<i>ceived by OCD: 7/17/2024 9:45:43 AM</i> U.S. Department of the Interior BUREAU OF LAND MANAGEMENT		Sundry Print Report 07/17/2024
Well Name: POKER LAKE UNIT CVX JV RR	Well Location: T25S / R30E / SEC 19 / SESE / 32.1085077 / -103.9136106	County or Parish/State: EDDY / NM
Well Number: 3H	Type of Well: OIL WELL	Allottee or Tribe Name:
Lease Number: NMLC070341	Unit or CA Name: PLU ROSS RANCH 19 FEDERAL 1H	Unit or CA Number: NMNM71016N
US Well Number: 3001537800	Operator: XTO PERMIAN OPERATING LLC

PLUG AND ABANDON WELLBORE POKER LAKE UNIT CVX JV RR 003H EDDY COUNTY, NEW MEXICO Class II

PLU CVX JV RR 003H - Proposed WBD

BLM Revised Procedure

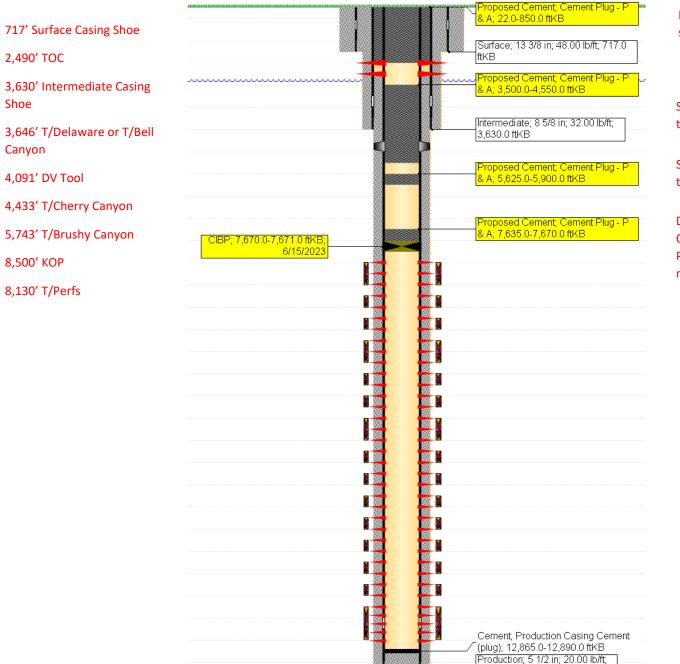
Perf and circulate 850' to surface.

Spot 100 Class C from 4,550' to 3,500'. WOC and Tag.

Spot 25 Class C from 5,900' to 5,625'. WOC and Tag.

Dump bail 35' **Class H** atop CIBP from 7,670' to 7,635'. PT CIBP to 500 PSIG for 30 min. WOC and Tag.

- 1. MIRU, NU and Test BOP.
- 2. Set CIBP at 8080'. Spot 35' Cl H cmt from 8080'- 8045'. Pressure Test WOC and Tag.
- 3. Spot Cl H cmt from 7670' to 7470'.
- 4. RUN CBL and contact BLM after operator run CBL.
- 5. Spot 25 sx Cl C from 5900' to 5625'. WOC and Tag (T/Brushy Canyon)
- 6. Spot 100sx from 4550' to 3500'. WOC and Tag (DV Tool, T/Delaware, Int. Shoe, B/Salt)
- 7. Perf and Sqz ~190 sx Cl C cmt from 850' to surface.

Set Dry Hole Marker.
